**MATANUSKA-SUSITNA BOROUGH
PLATTING BOARD
AGENDA**

December 15, 2016

PRELIMINARY PLAT: **HILLTOP ESTATES RSB LOTS 1, 10 & 11
PARTIAL VACATION OF W. LAUREN DRIVE
15' WIDE UTILITY EASEMENT MODIFICATION**

HILLTOP ESTATES SUBDIVISION
LOTS 1A, 10A, AND 11A

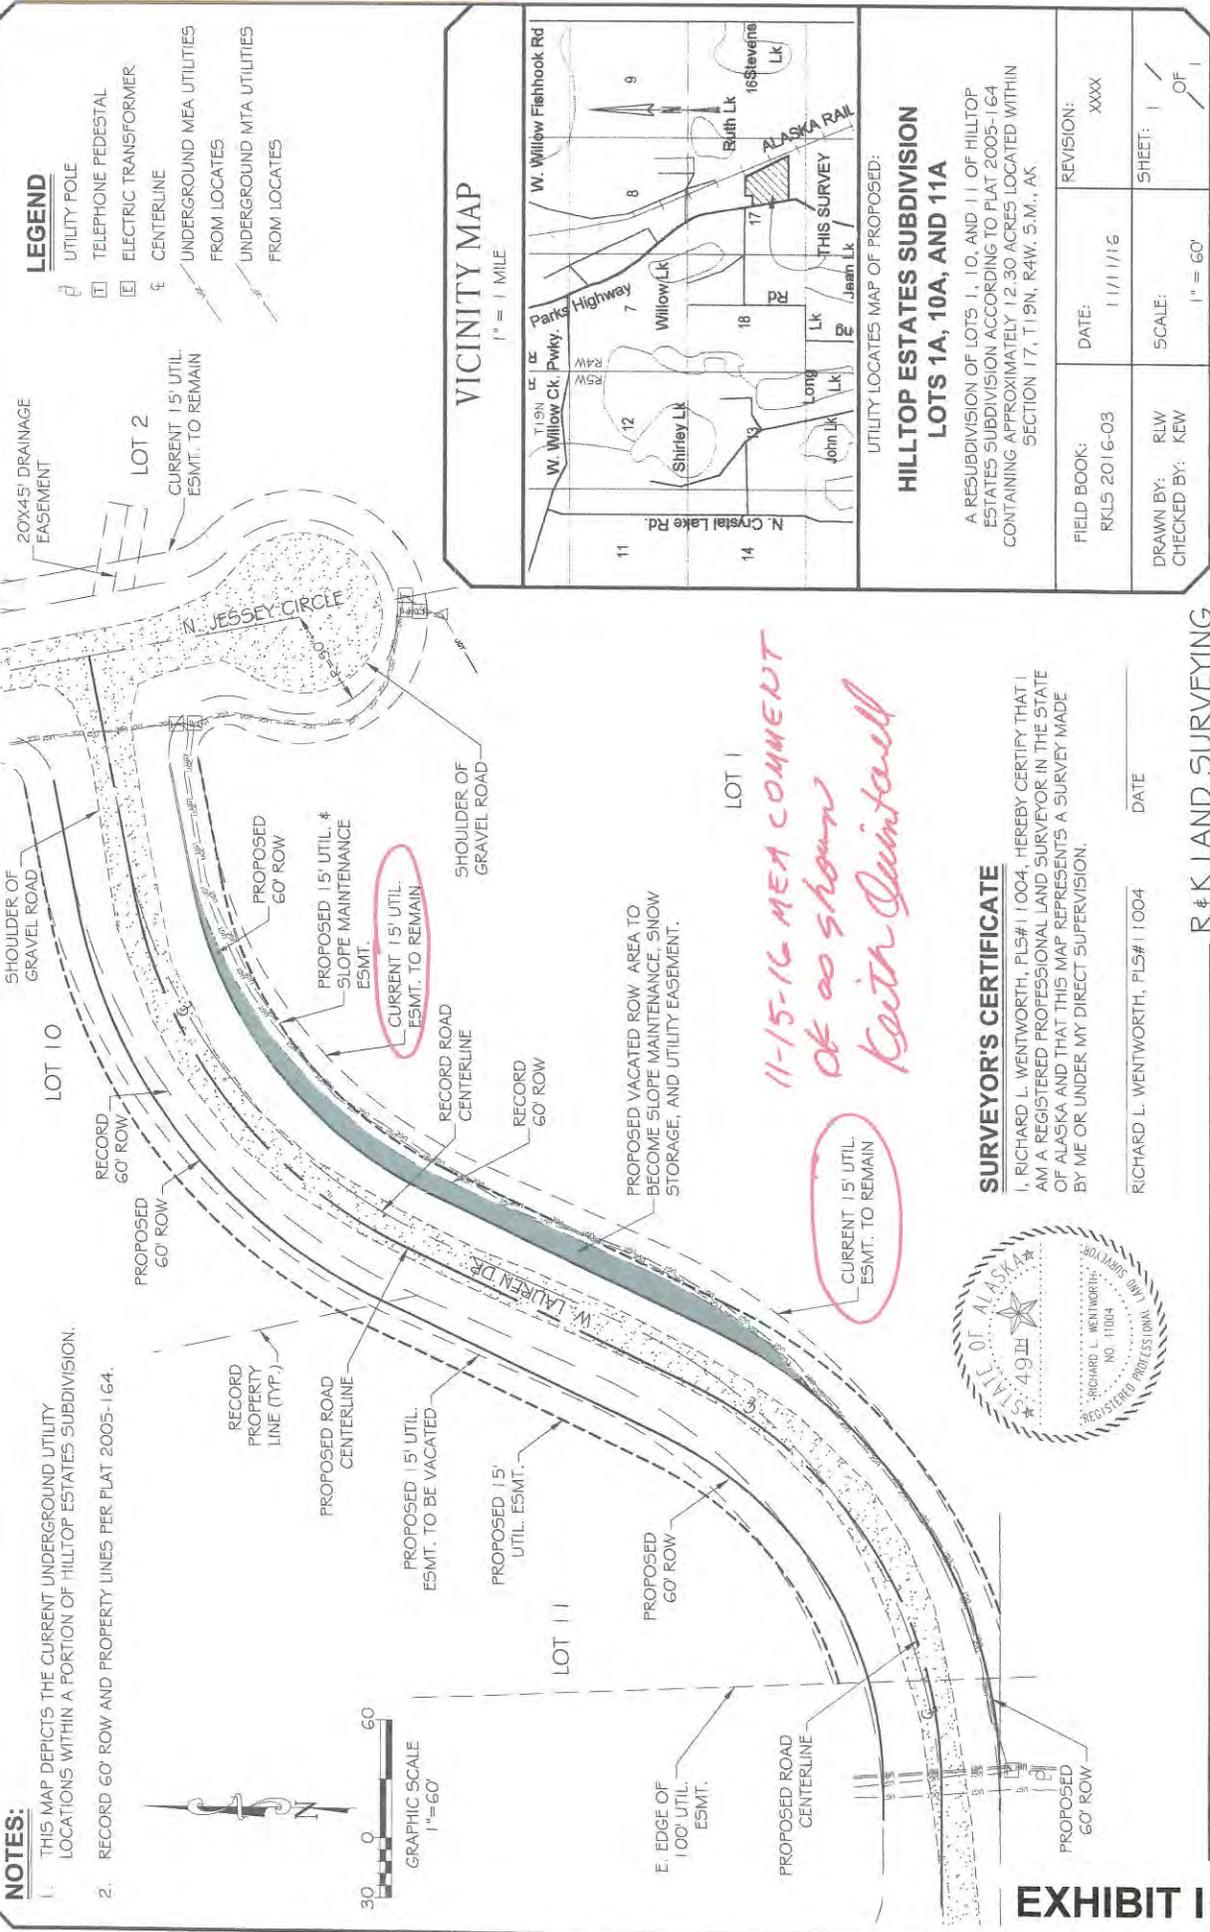
LOT 1
11-15-16 MEA COMMENT
OK as shown
Keith Quintard

Matanuska Electric Association, Inc. (MEA) has existing underground primary electric cable located in the existing easement along the SE side of the existing road right-of-way. MEA objects to relocation of the existing utility easement on the SE side of road right-of-way, or to the addition of a slope easement to the utility easement. MEA facilities should be located and added to the as-built to allow MEA to provide further comments on the proposed changes.

EXHIBIT K-2

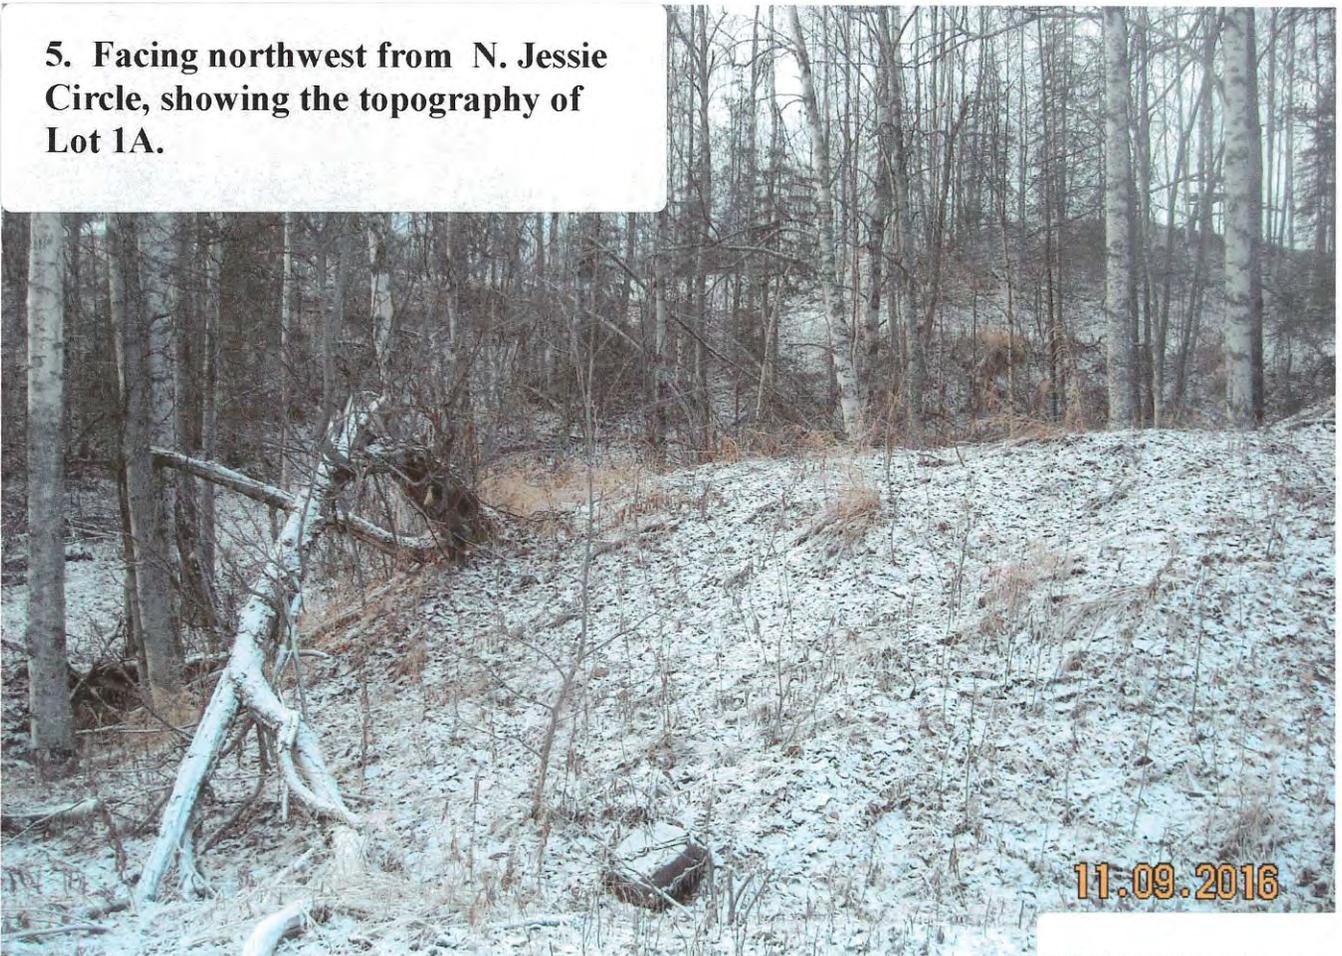
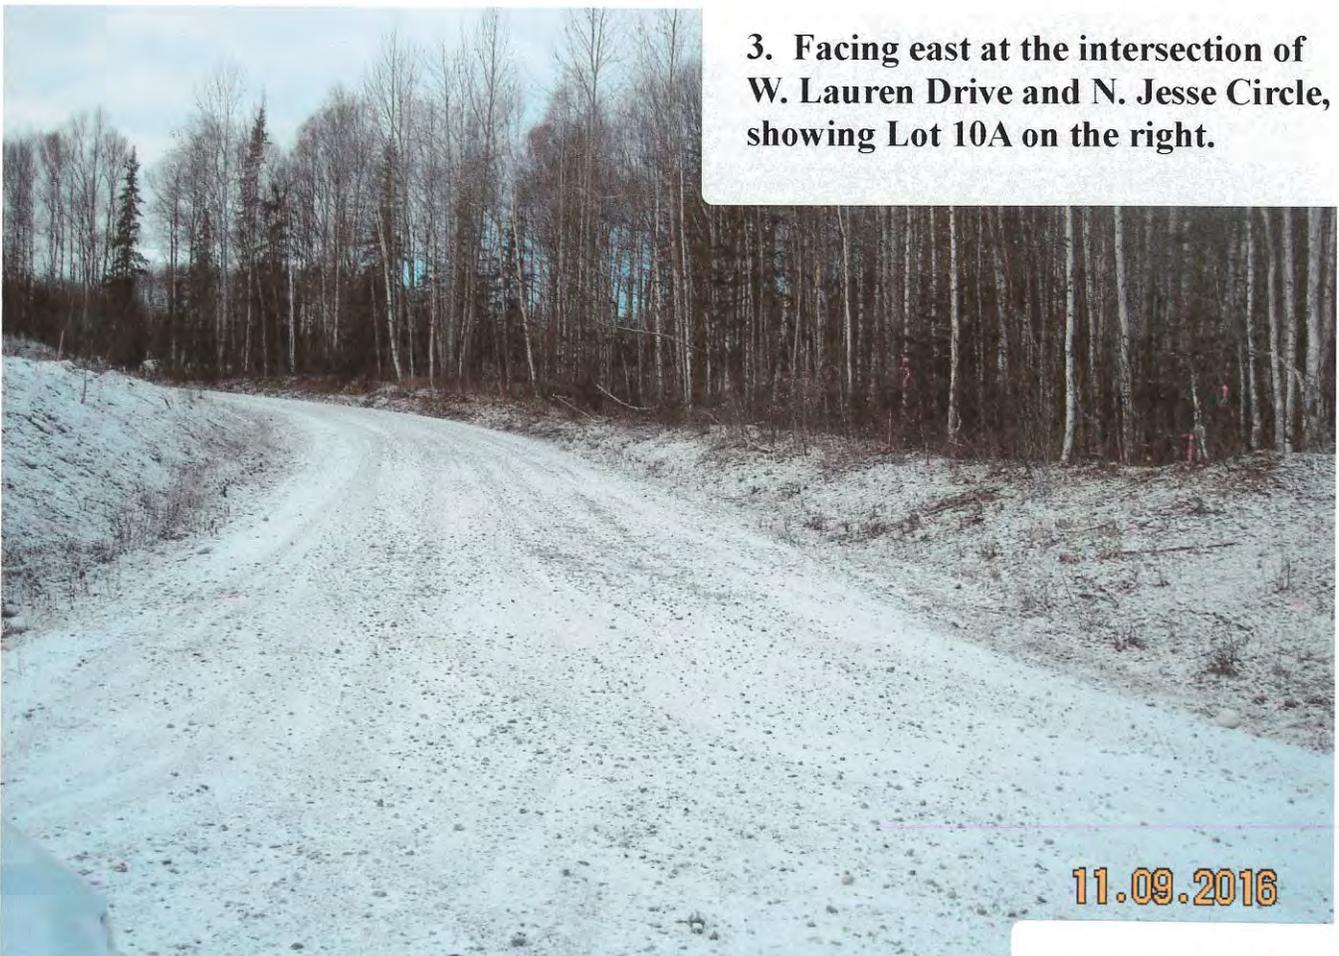
1. Facing east on W. Lauren Drive, showing the structure built too close to the right-of-way.

**2. Facing east on W. Lauren Drive,
showing the structure built too close
to the right-of-way.**
